# SERVICE BULLETIN

SB1278

<b>ADDRESSEES</b>	: ABC Customer Care and Parts Source Owners and operators of coaches listed under 'Application'
<b>VEHICLE MODEL</b>	: TD925US with steered trailing axle
<b>MANUAL SECTION</b>	: Chapter 07.10: Trailing axle steering system
<b>BULLETIN TYPE</b>	: Field Change Program
<b>DATE</b>	: May 4th, 2015
<b>SUBJECT</b>	: <b>To replace pivot bearing of hydraulic steering cylinder and greasing recommendations</b>
<b>TERMS &amp; CONDITIONS</b>	: Refer to the warranty section further in this Bulletin.

Figure 2: Valve block of trailing axle steering system (in step well of luggage compartment)

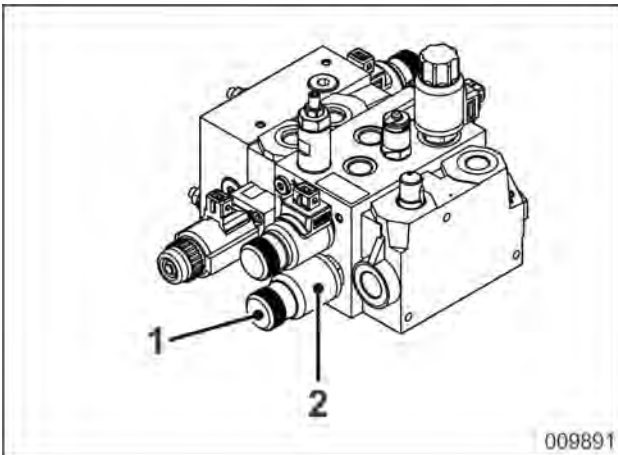
Step	Action
1	Disconnect the pressure relief valve connector.
2	Unscrew pressure relief valve end cap (1).
3	<p><i>NOTE: Make sure not to lose the O-ring when removing the coil.</i></p> <p>Remove pressure relief valve coil (2).</p>
4	<p>Screw on end cap (1) until you feel a firm resistance.</p> <p>The pin at the end cap inside now opens the pressure relief valve.</p>
5	<p>Check on the pressure gauge whether the pressure has fallen down.</p> <div data-bbox="571 1061 1198 1518" data-label="Image"> </div>
